## **URGENT FIELD SAFETY NOTICE**

### **Information about the recommended set up of the RAPID C-Spine Coil**

Product Name : OASIS

Fig.1 Balun of the RAPID C-Spine coil

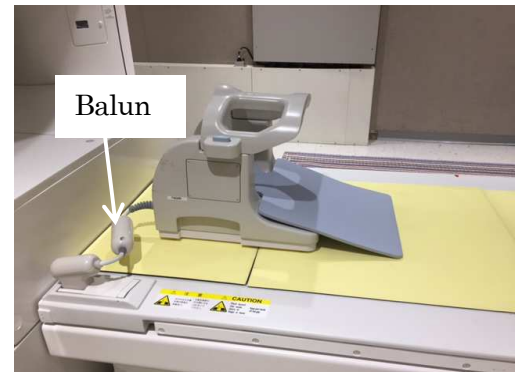
Hitachi had discovered that under rare circumstances, the balun attached the RAPID C-Spine coil cable can be overheated. Although there is no the suffering health harm at that time, it is possible to suffer the health harm depending on the degree of the heating surface temperature on balun cover.

Hitachi will be implementing a corrective action to replace the RAPID C-Spine Coil cable balun with an improved version.

Fig.2 Recommended set up

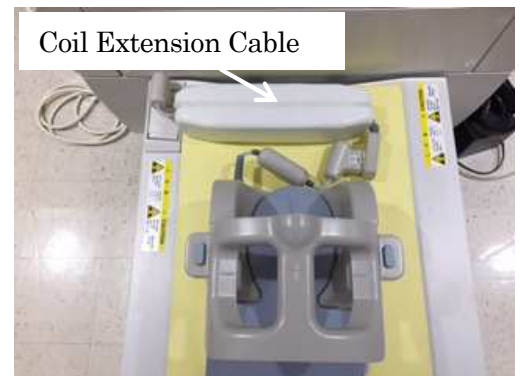
Until such time that the corrective action can be performed at your facility, we ask that you connect the Coil Extension Cable for all exams using the RAPID C-Spine Coil. See Fig.2 for the recommended set up of the coil and extension cable on the OASIS patient table. All in the Coil Extension Cable Guide remains applicable.
